FINAL ENVIRONMENTAL ASSESSMENT
FOR
HYDROPOWER LICENSES

Piedmont Hydroelectric Project, P-2428-007

Upper Pelzer Hydroelectric Project, P-10254-026

Lower Pelzer Hydroelectric Project, P-10253-032

Figure 7. Wetlands identified by NWI and the 2014 Wetlands and Riparian Habitat Inventory within and adjacent to the applicant’s study area at the Piedmont Project.
 (Source: Aquenergy, as modified by staff).

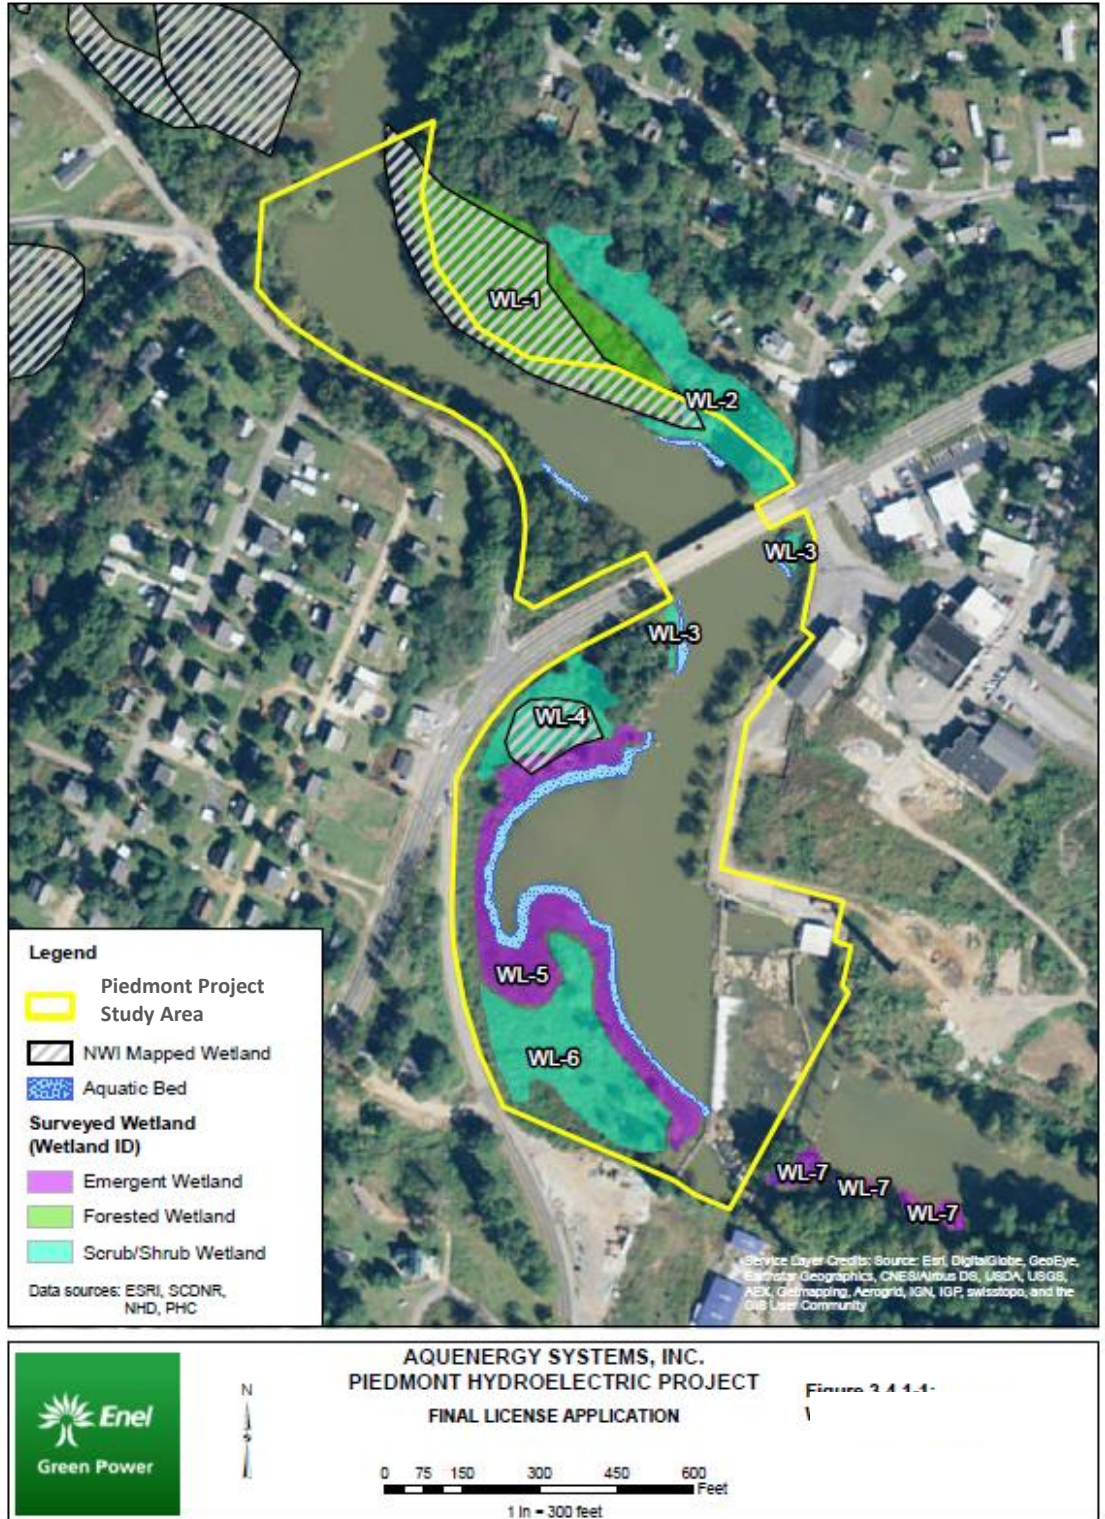
Comment: South Carolina DNR states that on page 96, section 3.3.3.1, *Terrestrial Resources—Affected Environment*, of the draft EA, figure 7 is inconsistent with related figures 8 through 12. Specifically, South Carolina DNR points out that the legend of figure 7 states that it shows wetlands within the Piedmont Project “Study Area,” while figures 8 through 12 show wetlands within the entirety of the Upper and Lower Pelzer projects’ boundaries.

Response: Unlike the Upper and Lower Pelzer Projects, for which the wetland survey area matched the project boundary, for the Piedmont Project, the applicant’s study area for the 2014 Wetlands and Riparian Habitat Inventory encompassed a smaller area within the project boundary. While the legend in the license application and the draft EA incorrectly identified the area in this figure as the project boundary, figure 7 accurately displayed the area covered in the applicant’s wetland study. We have corrected the legend accordingly.
